Planning Memorandum

Re: 11 Salem Lane – Major Site Plan Review
WSB Project No. 021843-000

**RESOLUTION APPROVING A MAJOR SITE PLAN AND BUILDING REVIEW FOR
THE PROPERTY AT 11 SALEM LANE, SUNFISH LAKE, DAKOTA COUNTY,
MINNESOTA.**

EXISTING SITE
TREE/HARDSCAPE
REMOVAL PLAN

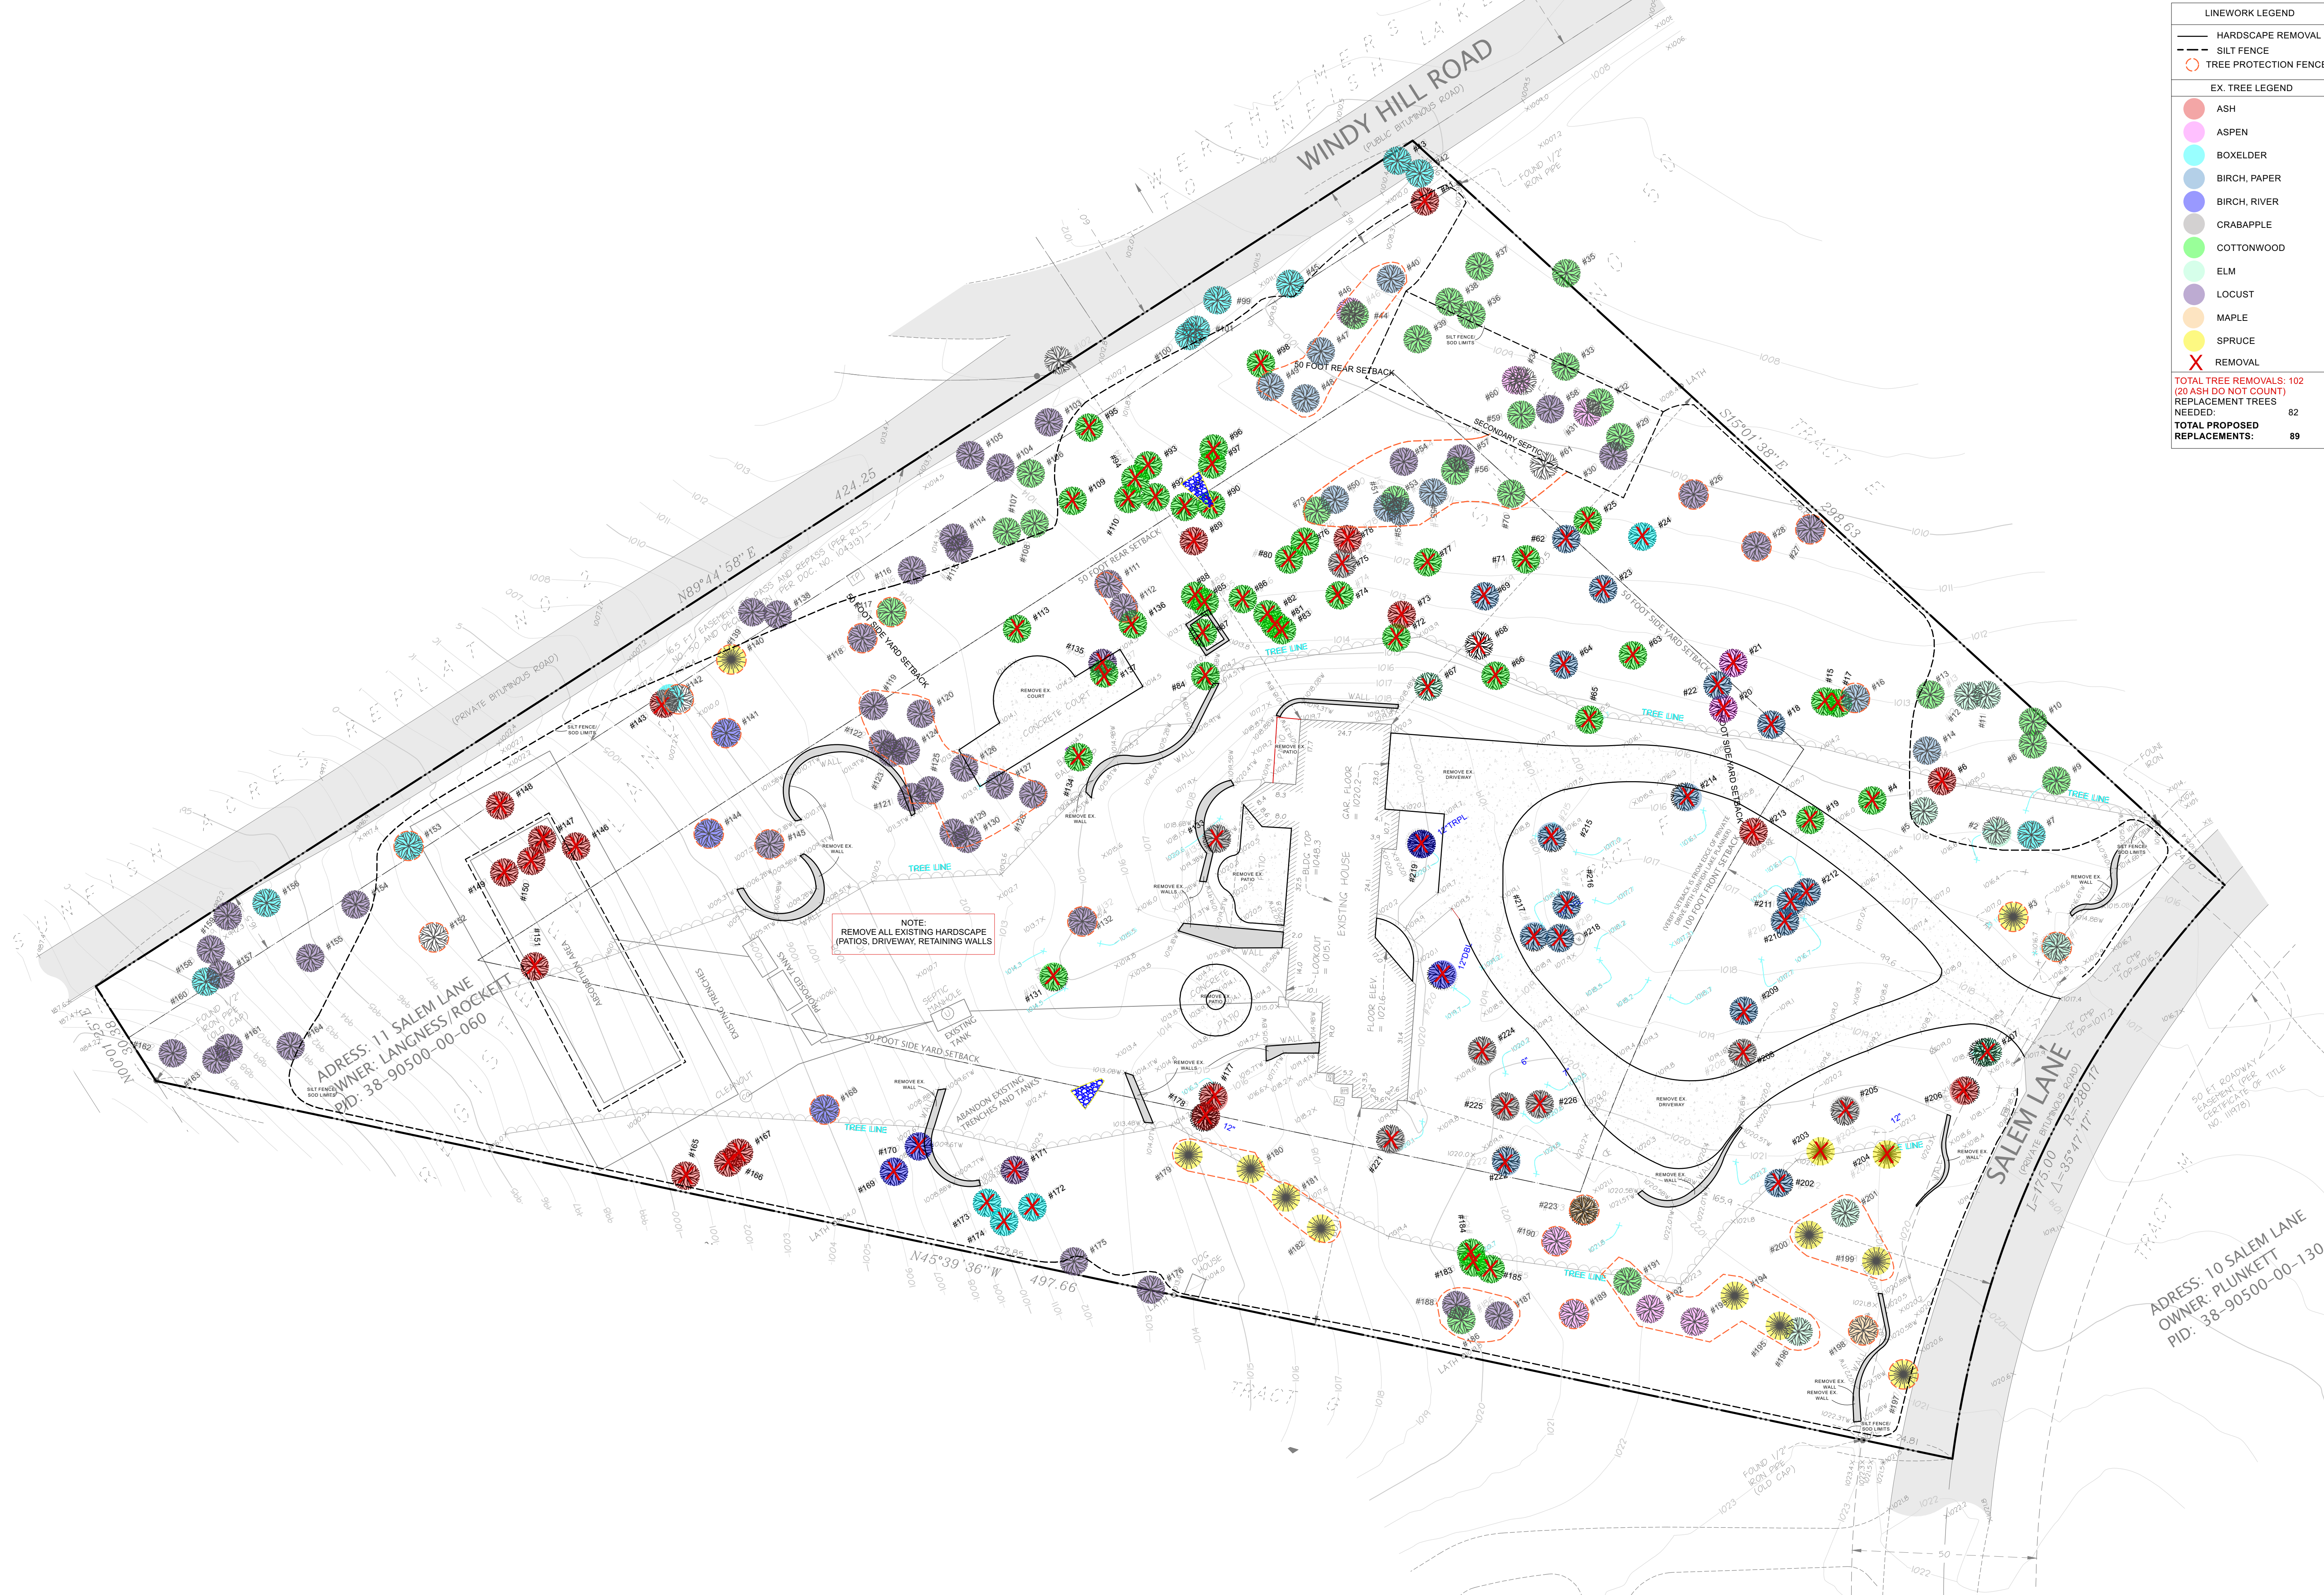
Tree Preservation: There will be 102 trees removed on site to accommodate the construction of the new home. Twenty of the removed trees are ash trees and they are not counted towards the final mitigation plan as they are not a preferred species.

2 ENTRY GATE
SCALE: 1/4" = 1'-0"

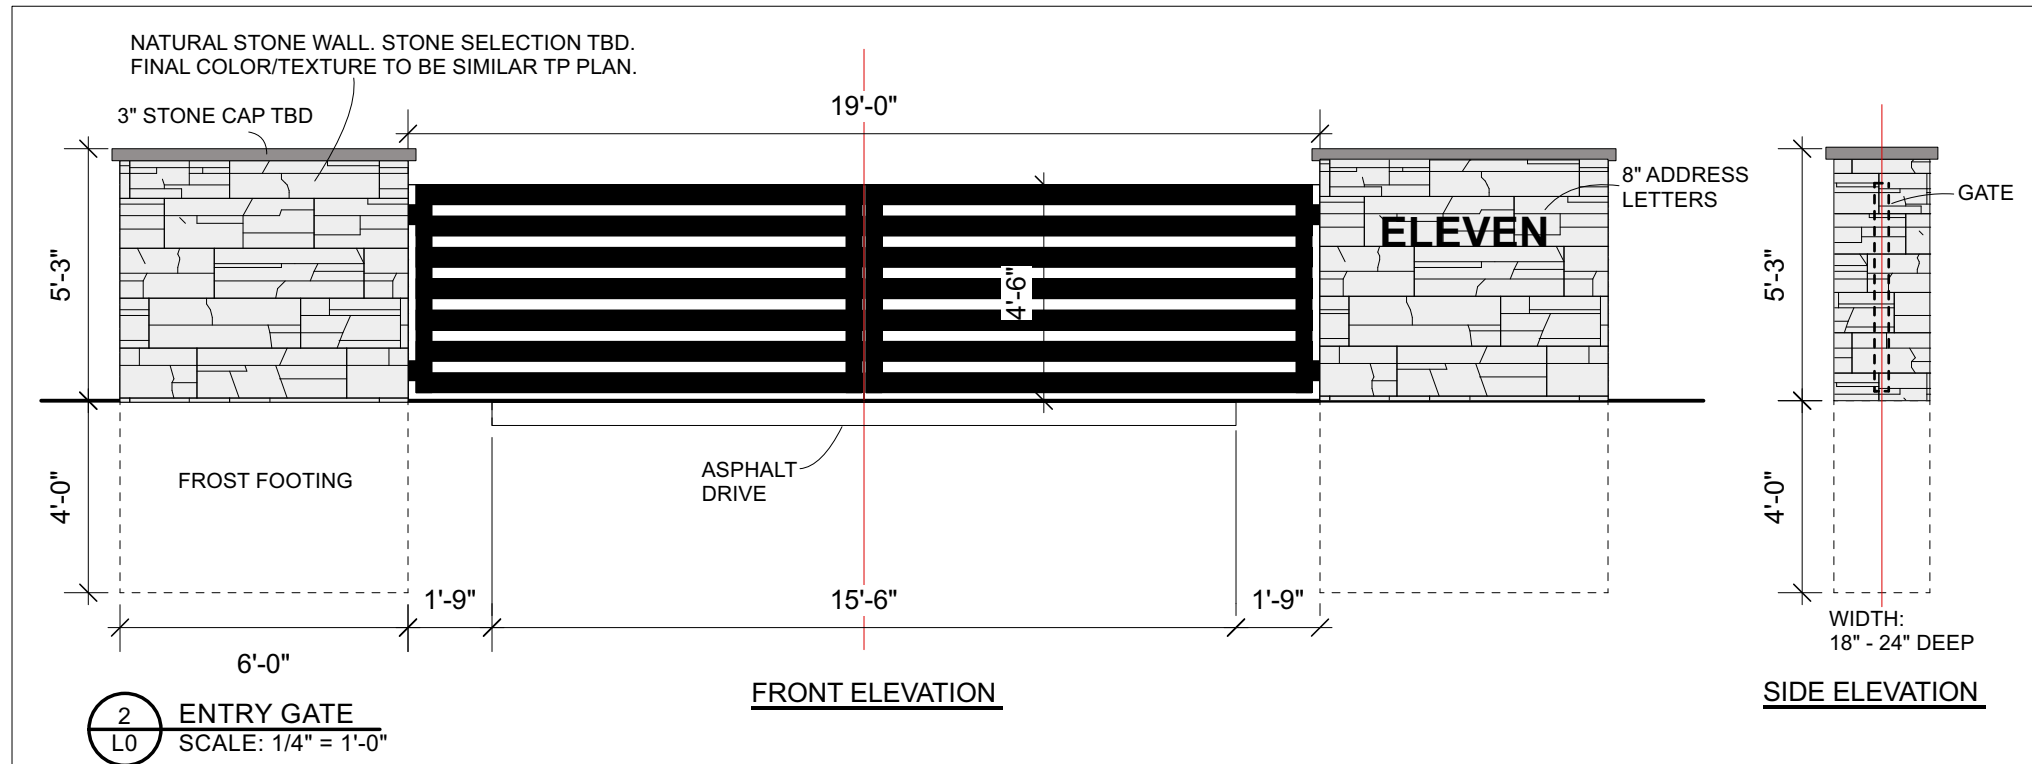
Also included on the landscape plan is the installation of monuments with a gate at the entrance to the site from Salem Lane. The zoning ordinance indicates that a conditional use permit is required for all security gates. The zoning ordinance also requires that such gates must be within the buildable area of the lot, which would mean that the gate would need to be located 100 feet from the front property line. The gate and monument as proposed would not meet this requirement. Therefore, a variance to the setback requirement would be required unless the gate

is moved past the front yard setback line. A condition has been added to the approval of the major site and building plan review that a conditional use permit and possibly a variance would need to be obtained before permits are granted for the security gate and associated monuments.

12. The applicant to submit a new landscape plan with tree installation sizes.
13. A conditional use permit and possibly a variance would need to be obtained before permits are granted for the security gate and associated monuments. No work can begin on the monuments or gate until the necessary approvals have been granted. If the applicant wishes to begin work on the rest of the development on this lot, a new site plan must be submitted that removes the monument and the gate from the plans prior to issuance of building permit.
